October 15, 2015

SUBJECT: TOTE ADMINISTRATION BUILDING HVAC UPGRADE
PROJECT NO. 098034
CONTRACT NO. 070083

ADDENDUM NUMBER ONE

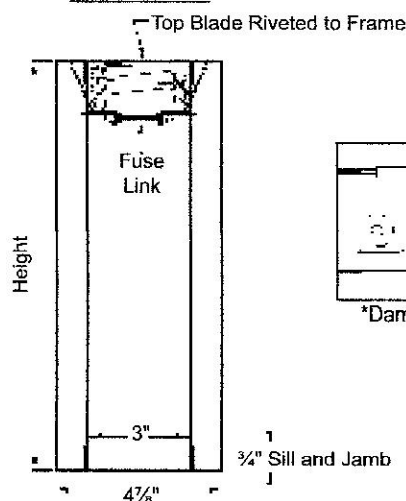
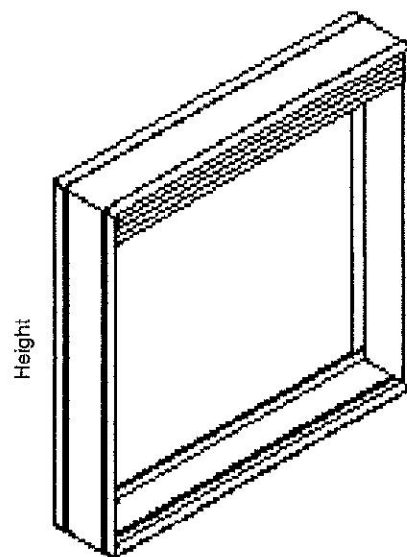
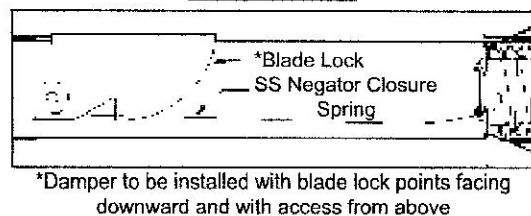
1. **Section 2.04** - Air Balance (Fire Dampers) is **NOT** approved as noted in Substitution request (Attachment A)

Specification Title: AIR DUCT ACCESSORIES Section No. 23 33 00
Description: FIRE DAMPERS Paragraph: 2.04
Page No. 3

Proposed Substitution: AIR BALANCE
Trade Name: MESTEK Model No.: 119
Manufacturer: _____
Address: 450 RIVERSIDE DR WYALUSING PA 18853 Phone No.: 570 746 1888

- ☐ Substitution approved
☐ Substitution approved as noted
☒ Substitution rejected - Use specified materials. - Provide dynamic rated fire damper.
☐ Substitution Request received too late - Use specified materials.

SQD

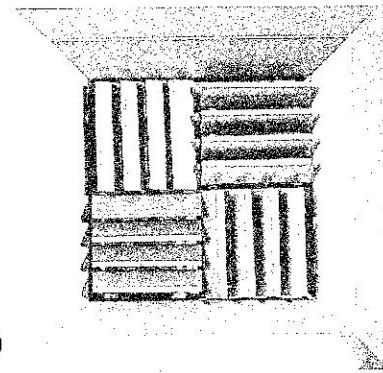
1. **Section 2.01-2.02** - **ADD** Tuttle & Bailey (Air System Components) as an approved Substitution (Attachment B)

Model No.: SQD, CRES00

- ☒ Substitution approved
☐ Substitution approved as noted
☐ Substitution rejected - Use specified materials.
☐ Substitution Request received too late - Use specified materials.
